Paper #GMD-2024-87 | Model experiment description paper: 'Design, evaluation and future projections of the NARClIM2.0 CORDEX-CMIP6 Australasia regional climate ensemble'

Table 1. Anonymous Referee 1 (RC1) Comments

Table 2. Anonymous Referee 2 (RC2) Comments

Table 3. Anonymous Referee 3 (RC3) Comments

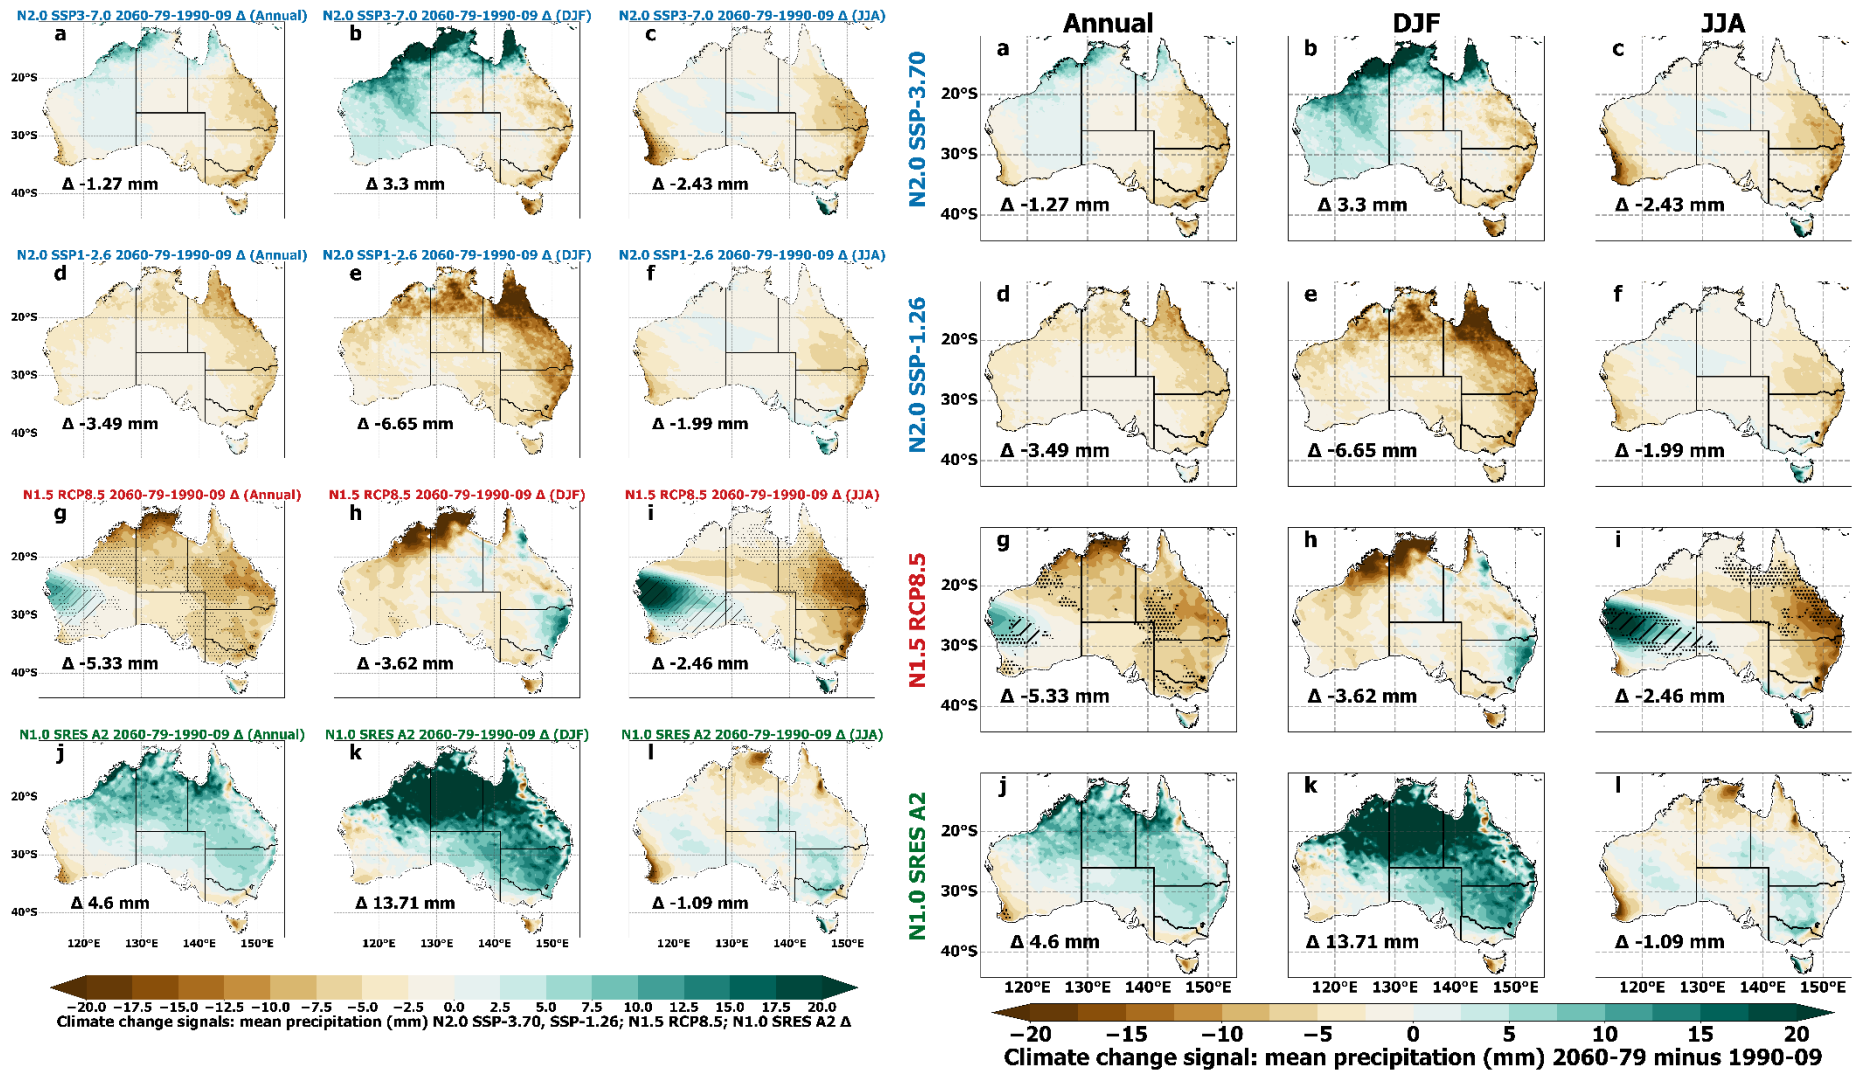
9	Figure 4, for precip, are the units mm/day?	Thanks for asking this question, yes, the units are mm/day – figure caption revised accordingly.	Figure caption revised for units.
10	Figure 9 (and others), I found it difficult to see the stippling/hatching. The resolution of the file was low (not sure if this was an issue with the pdf	We agree that Figure 15 is difficult to read, e.g. the original version was 300 DPI; we have now increased the DPI to 600, among other	Figure 15 revised as suggested (please see example below this table, p.24).

preprint?) but please ensure that high resolution figures are used and that the journal isn't compressing these in the final version. The resolution is particularly low for Figure 15 and very difficult to read.	modifications. We have revised this plot, please see the example new Figure 15 below this table (p. 24).	
11	I think in some figures there is a lot more repetitive text than there needs to be. Rethinking the layout headers of certain figures would help. For example, Figure 9 and 12, (Annual, DJF, JJA) could simply be headers at the top of each page, and the different versions of Narclim could be along the LHS of page. The text is often also too small to read. E.g. the colorbar caption in Figure 15 is excessively long and this information could simply be in the caption.	Thanks for these suggestions. We have revised these figures as you have suggested – please see examples below this table (pp. 21-23).	Figures modified as suggested in the revised manuscript (please see examples below this table, pp. 21-23).

Figure 15: revised version

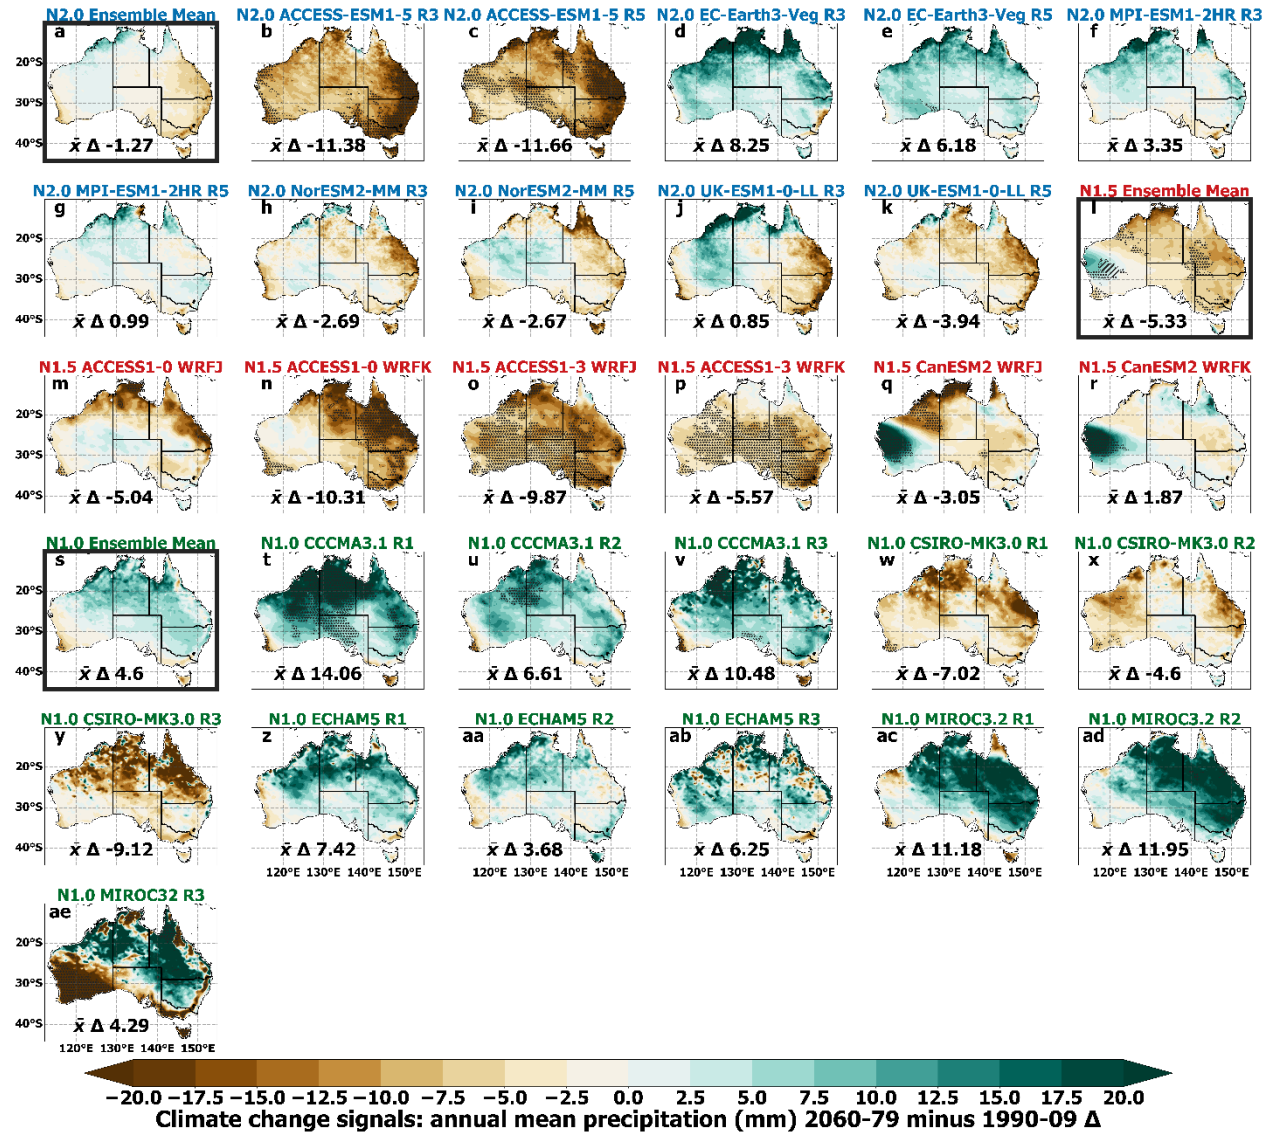
12	Figure 15: there are many subfigures and their titles are not easy to read. Please consider improve the visualization.	Agreed, the original Figure 15 was of insufficient quality (e.g. 300 DPI), so we	Figure 15 revised, please see example below this table.

have increased to 600 DPI and improved clarity of stippling and titles as far as is possible for a figure with 31 individual plot panels.	
13	Line 777: "with 4 RCMs using BMJ, 2 RCMs using Tiedtke, and 1 using Kain-Fritsch." Please give the references to the cumulus parameterisations.	This is a good idea – we have included references for all physics used in the study.	References for all physics settings used added into Table 3 (pp. 16-17) via an additional column in the revised manuscript.
